Flexi Classic : now with coding

Necessary product change Flexi Classic as of June 15th

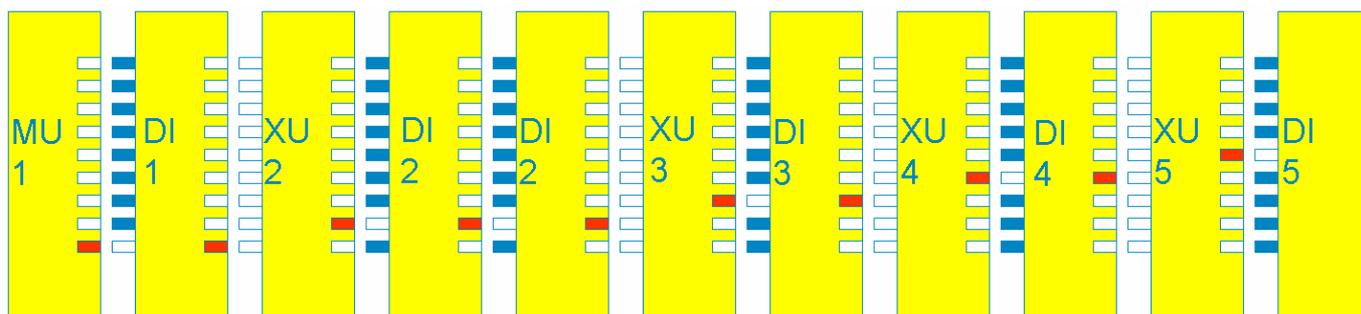
The way of doing this is to mechanically code the FlexBus connector. We have created 6 different codings, assuming 6 is the maximum number of subsystems including 8DI modules in a 13 module configuration.

The MU modules will only accept XU and 8DI modules having the first code.

The XU modules can fit onto any module, and can be set up to accept the correct code from 8DI.

The 8DI modules are mechanically coded on both sides.
